EXPEDITED MONTGOMERY COUNTY HISTORIC PRESERVATION COMMISSION STAFF REPORT

Address: 7207 Thornapple Place, Chevy Chase Meeting Date: 11/13/2019

Case Number: 35/96-19A REVISION

PROPOSAL: Building addition

SCALE: 1" = 10' DATE: 05-09-2019

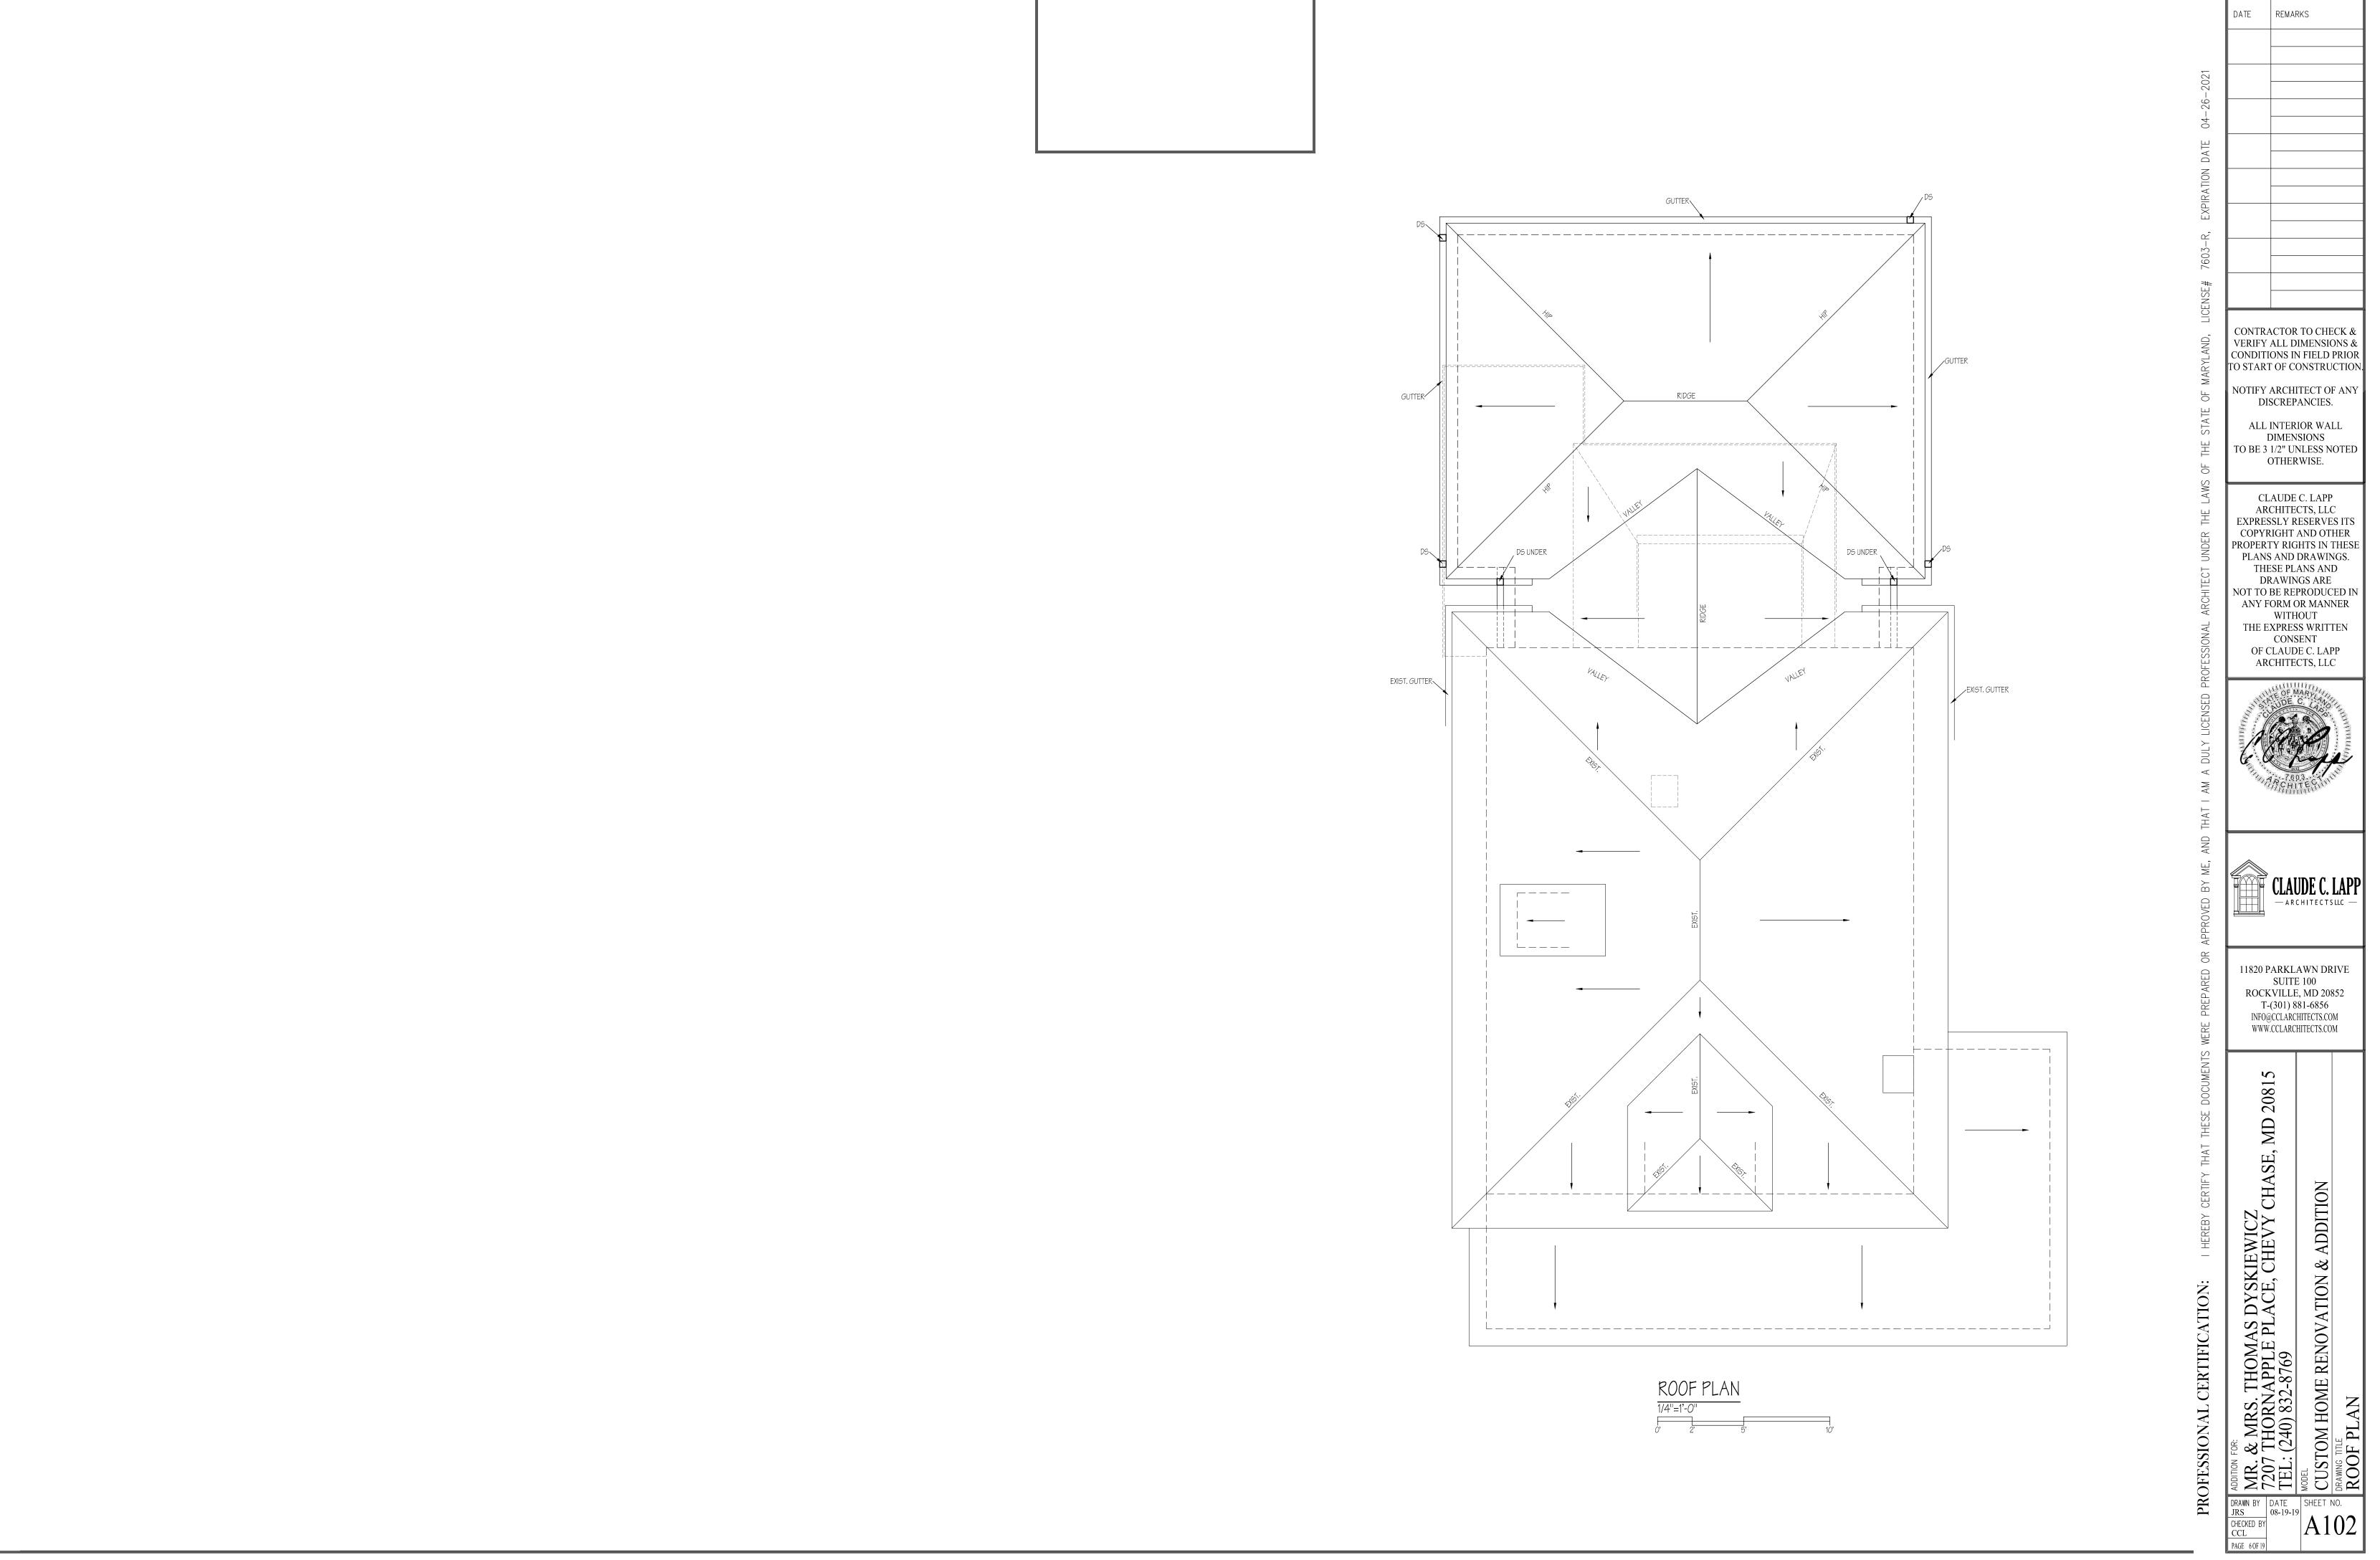
ADDED BILCO DOOR REPLACED DORMER

Basement Door Standard Sizes and Dimensions

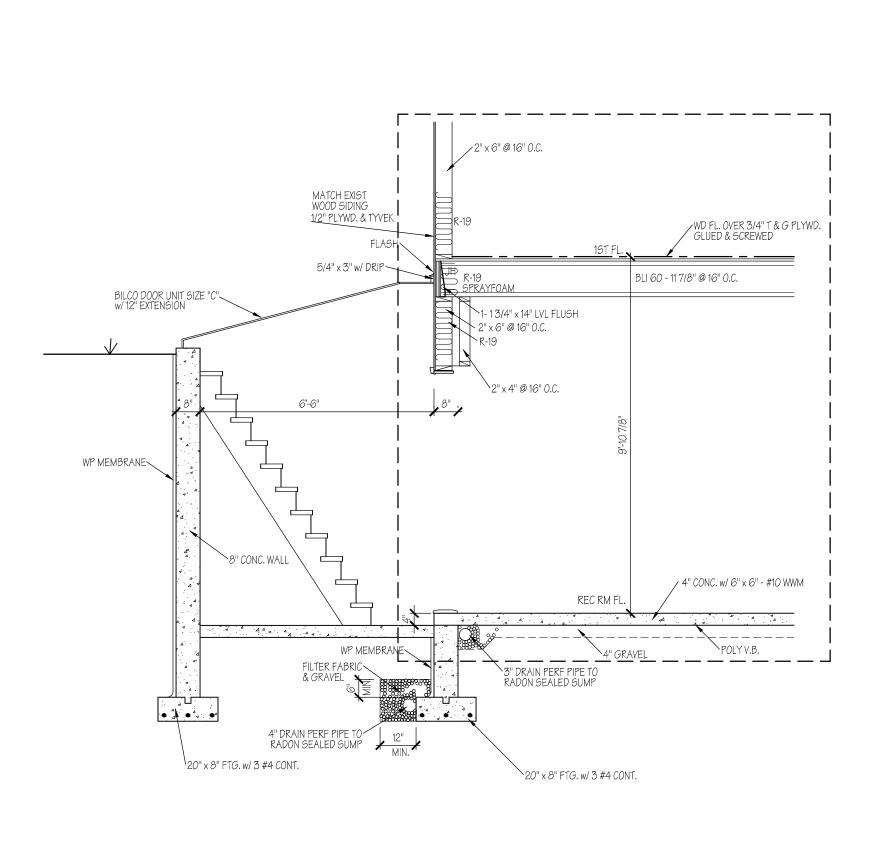
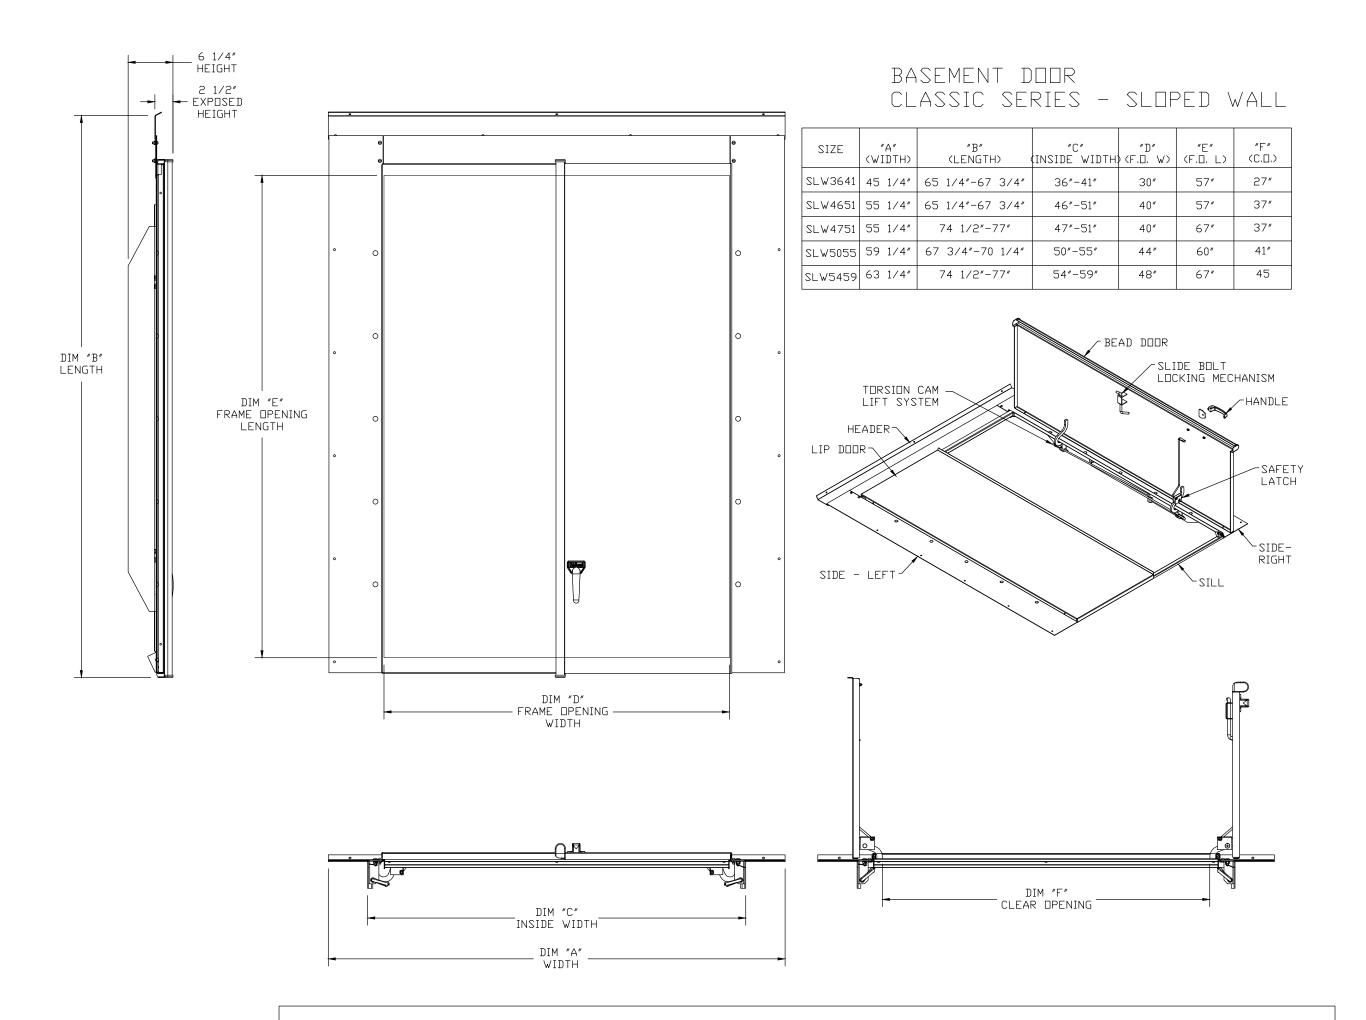
DATE REMARKS ADDED BILCO DOOR 10-16-19 SPECIFICATIONS CONTRACTOR TO CHECK & VERIFY ALL DIMENSIONS &
